# CITY OF ALBUQUERQUE

RE: **Starbuck's Menaul and Carlisle  
American Square  
Request for Certificate of Occupancy - Permanent  
Hydrology Final Inspection –Approved  
Grading and Drainage Plan Stamp Date: 10/24/19  
Certification Dated: 9/8/20  
Drainage File: H16D083E**

Starbucks Shell  
Grading and Drainage Plan  
Northwest Corner of Carlisle & Menaul  
Albuquerque, New Mexico

Starbucks Shell  
Grading and Drainage Plan

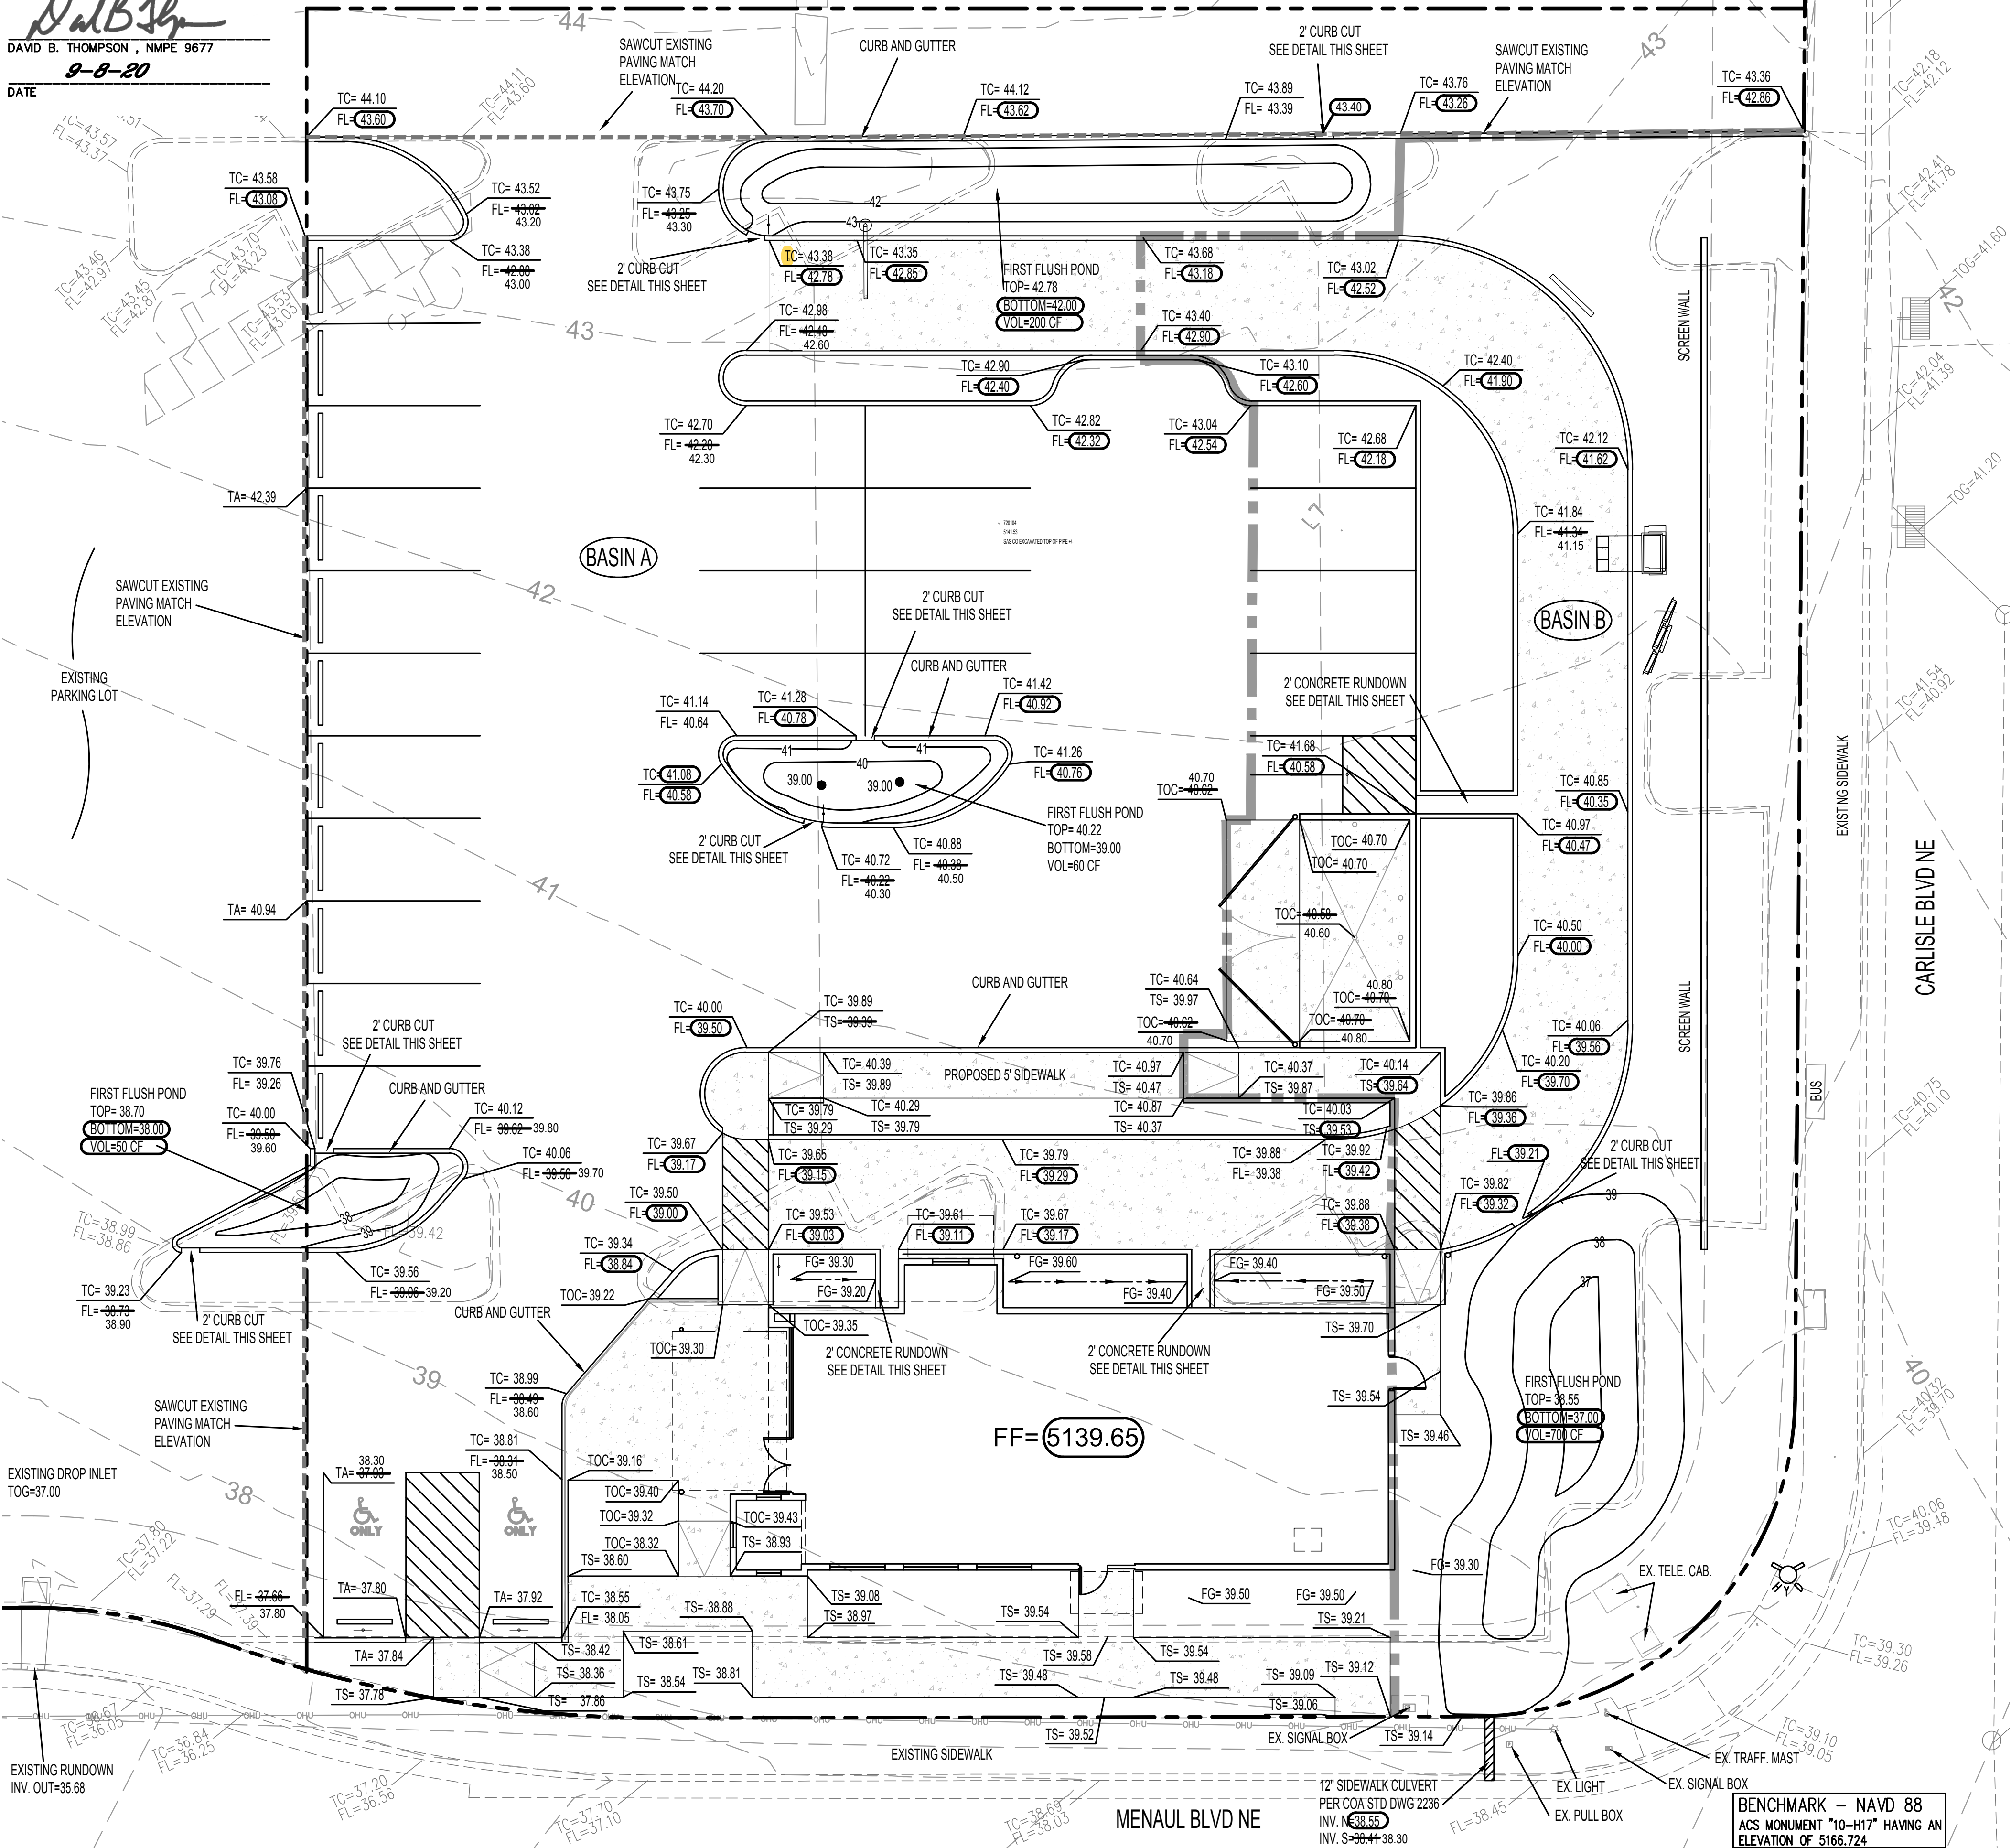
Based on the submittal received on 9/8/20 and field inspections 9/11/20, this certification is approved in support of Permanent Certificate of Occupancy by Hydrology. Please note that there is a discrepancy between the plan and what is in the field. The pond on the north side of the drive-thru entrance has a curb-cut adjacent to the entrance for storm flows to enter in to the pond, but the grades in the pond at this cut are higher than the cut and the grades outside this cut slope away from the pond. This will act more as an overflow than inlet, which is not needed for this pond. I am inclined to have this cut closed, but I do not believe it will be detrimental to the site drainage, so I will not require this to be done.
